# Rezoning Transportation Analysis

Petition Number: 2022-216

Date	Description
05-24-2023	First Review (JP)
11-27-2023	Second Review (TP)
12-19-2023	Third Review (IW)
01-24-2024	Fourth Review (KC)
02-28-2024	Fifth Review (TM)

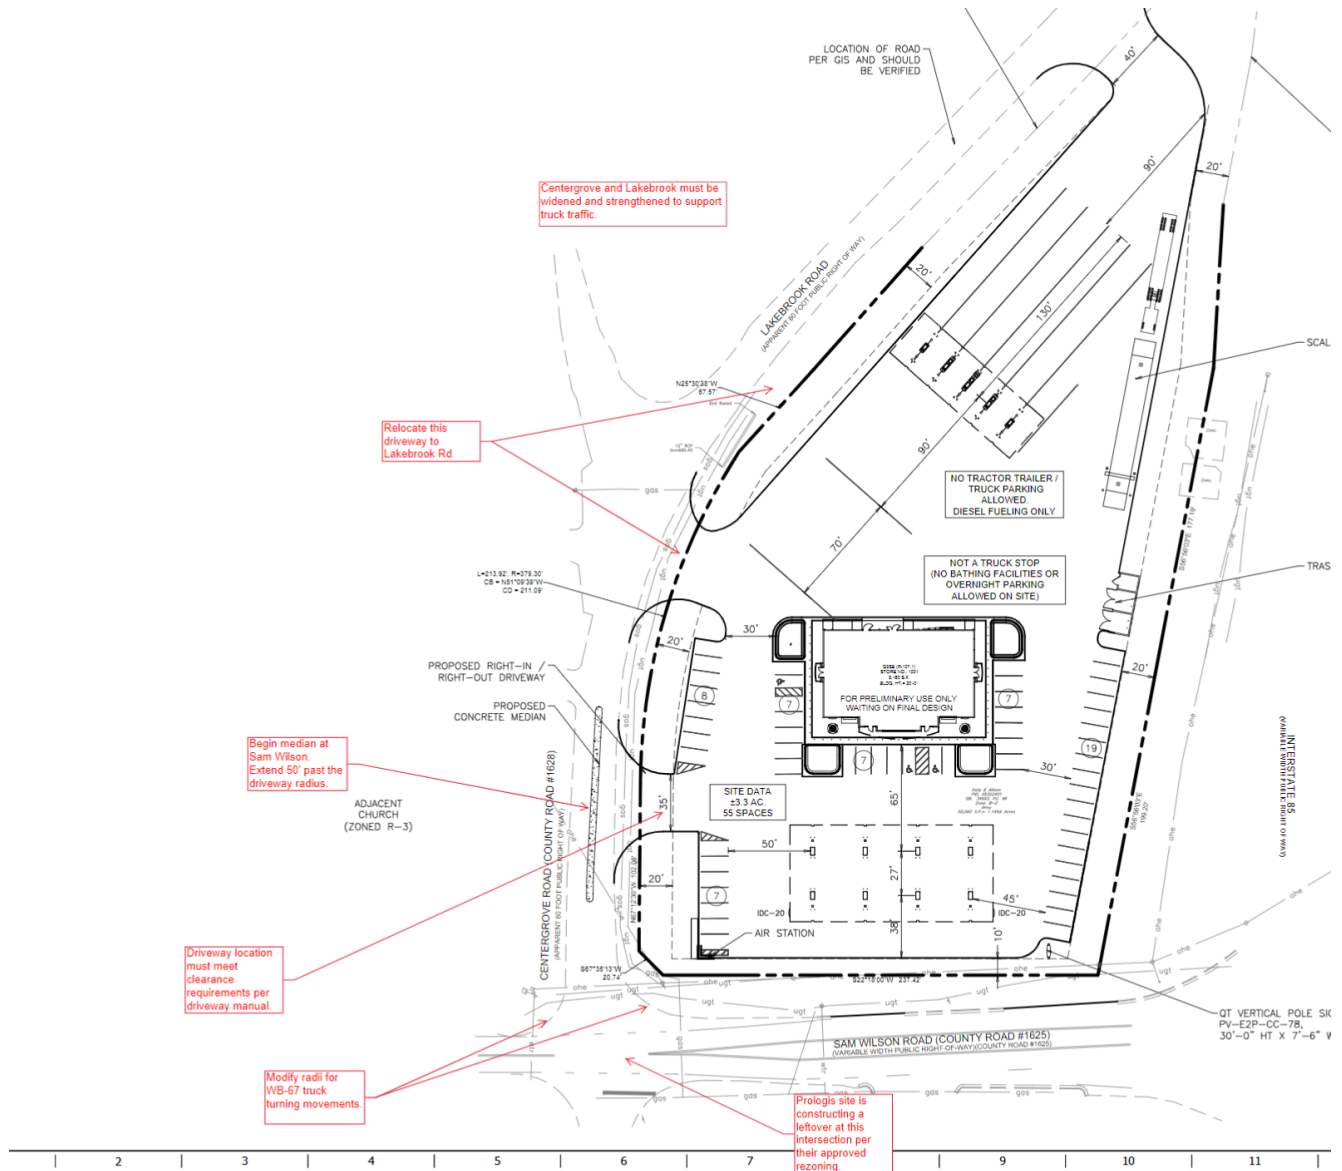
### 3. ~~Per coordination with NCDOT address the below access management comments.~~

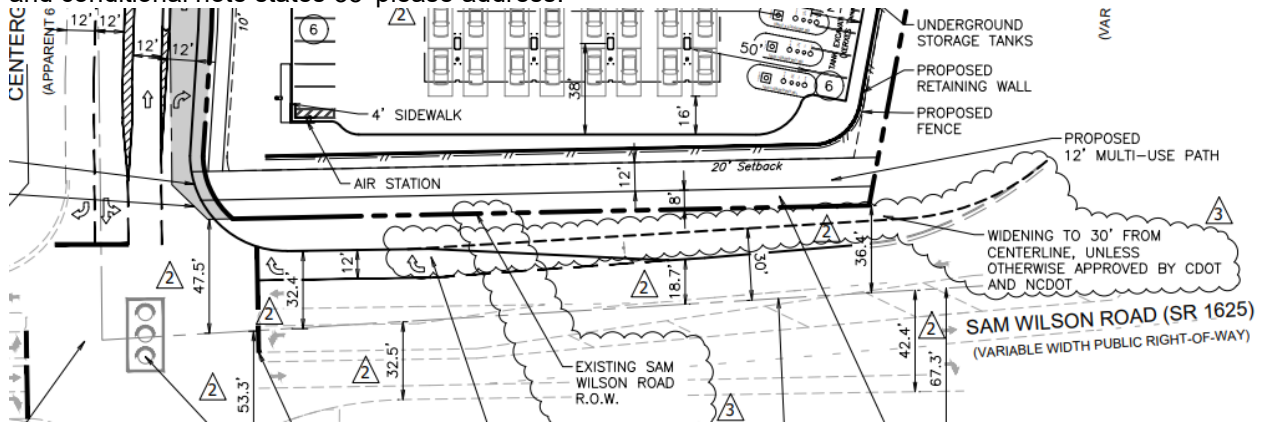
5. **New comment 01.24.2024:** Conflict with revised site plan and conditional notes, site plan shows 30' and conditional note states 35' please address.

4. Prior to the issuance of the first certificate of occupancy for the building to be constructed on the Site, Petitioner shall dedicate and convey to the City of Charlotte or to NCDOT as applicable (subject to a reservation for any necessary utility easements) those portions of the Site located immediately adjacent to Sam Wilson Road as required to provide right of way measuring 35 feet from the existing centerline of Sam Wilson Road, to the extent that such right of way does not already exist.

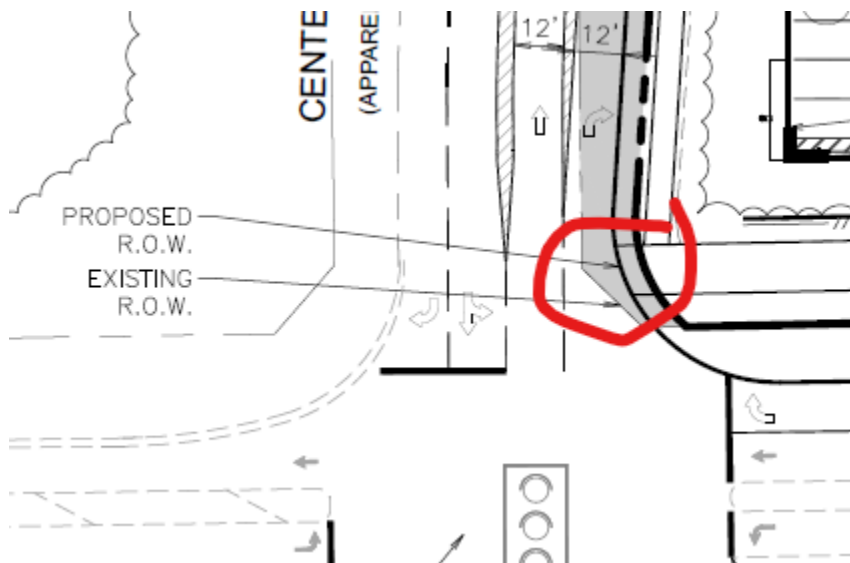
6. **New Comment 12-20-2023:** Revise site plan to clearly show and label the location of existing right of way and proposed right of way.

**Clarifying Comment 01.24.2024:** Label and clearly dimension the existing right of way and the proposed right of way.

**Clarifying Comment 02-28-2024:** Label and Dimension ROW, curb and gutter (existing and proposed) along Centergrove Road and Lakebrook Road. Dimensions shall be from roadway centerline.

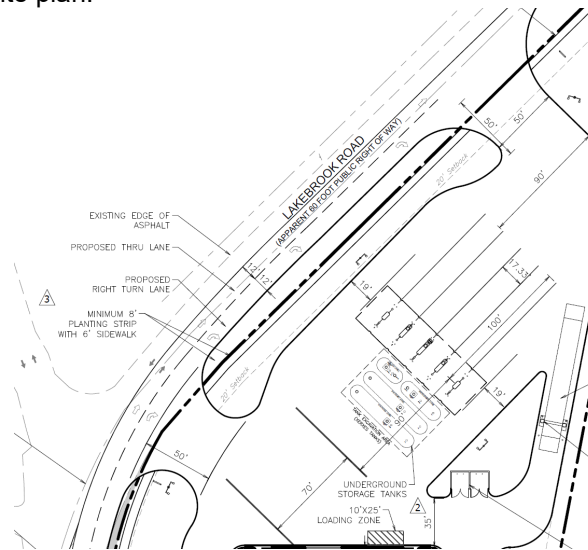
7. **New Comment 02-28-2024:** Driveway stem is measured from the ROW not the edge of travel. Revise dimension location and site plan.
